Amendments to the Drawings:

REMARKS

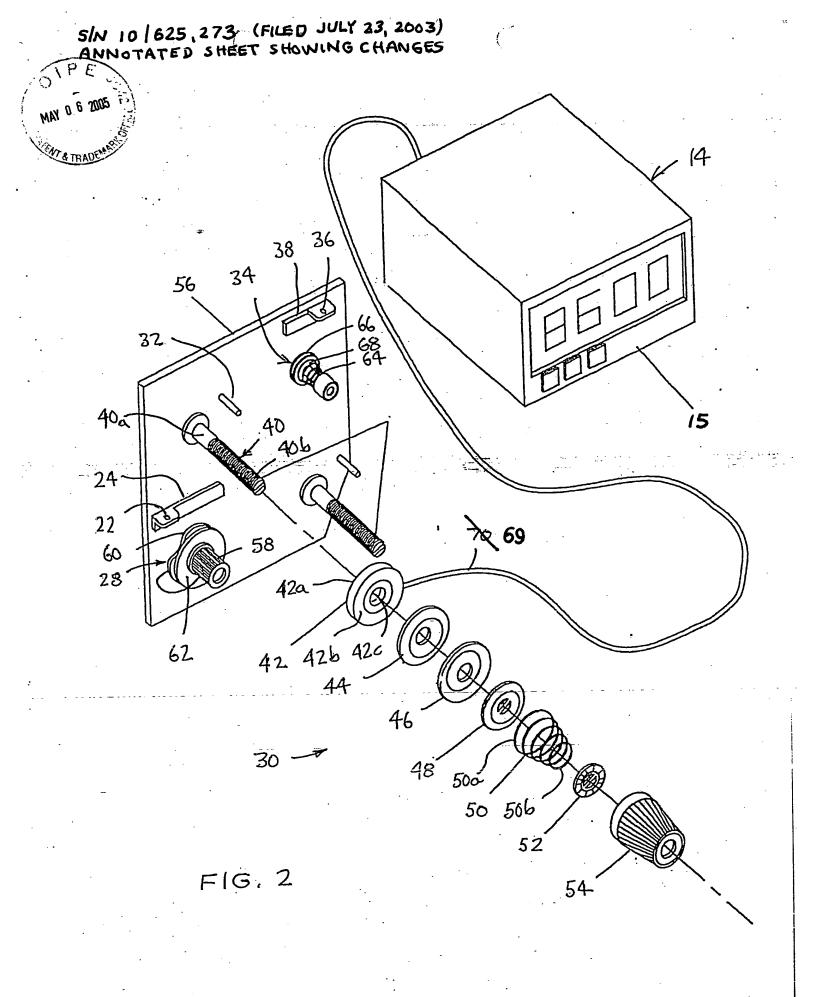
The changes to FIG. 2 comprise: (1) labeling the end of a lead line shown thereon, and pointing to a comparator, with the number -15-, and (2) changing the number of an electrical wire from "70" to "69".

The Examiner objected to the drawings, stating that the drawings must show every feature of the invention specified in the claims. In particular, the Examiner contended that a "comparator" recited in Claim 3 must be shown or the feature canceled from the Claim.

At the time of filing, Paragraph [00046] of the Specification discussed the comparator, and in FIG. 2 of the drawings. a lead line pointed to the comparator. Neither the term "comparator" nor the end of the lead line pointing thereto were labeled. By the action herein, Paragraph [00046] and FIG. 2 are amended by adding a number – 15 – after the word "comparator" and at the end of the lead line.

Accordingly, by the amendments herein to the Specification and to FIG. 2 of the drawings, the Examiner's objection is believed obviated.

F1G, 3

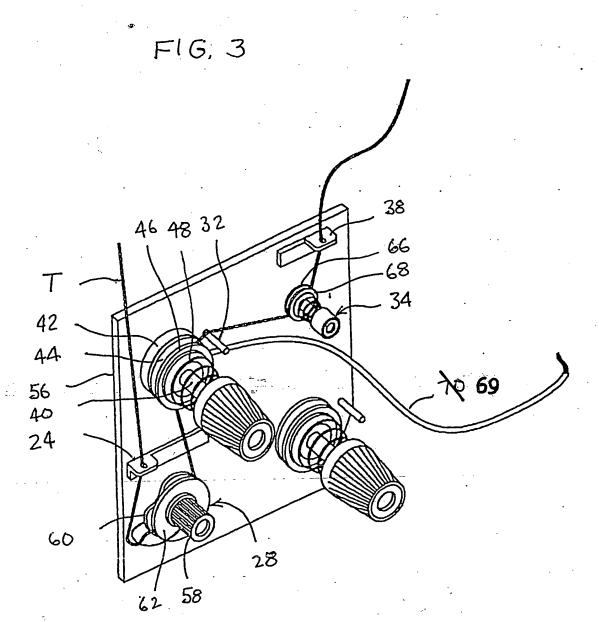
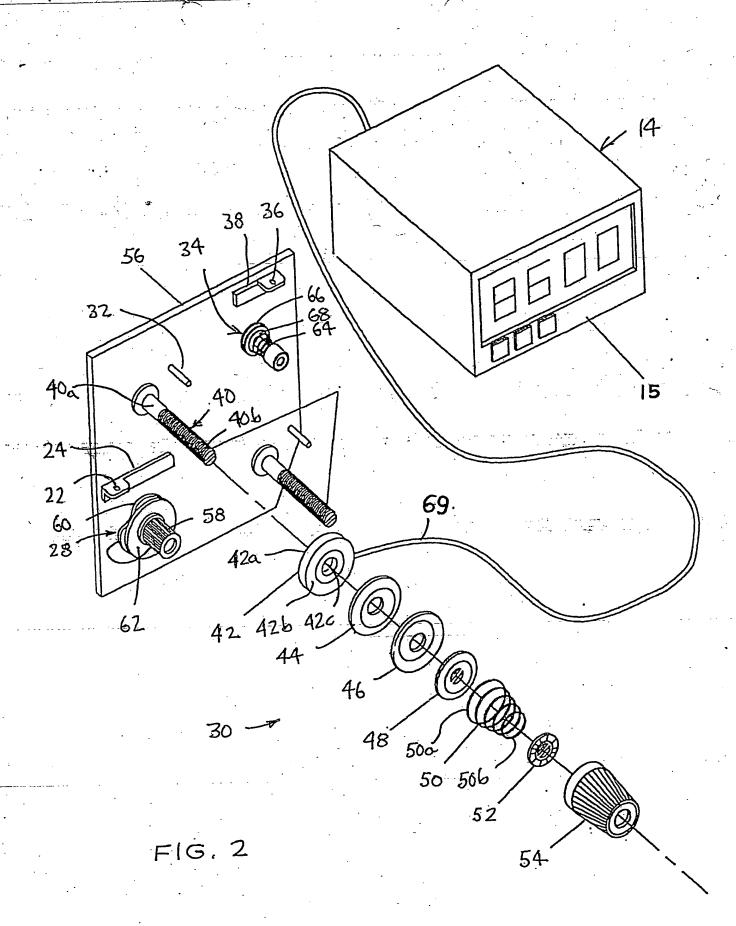
The change to FIG. 3 comprises changing the number of the electrical wire from "70" to " 69 ".

Further, upon review of the Application, Applicant's Attorney noted that the number "70" was used in the application to identify an electrical wire (e.g., FIGS. 2 and 3) and also to identify a spacer or cylinder (e.g., FIG. 4 and Paragraphs [00048], [00049], and [00051]). The amendment herein to FIGS. 2 and 3 and Paragraph [00039], wherein the wire is renumbered as "69", is believed to obviate any indefiniteness.
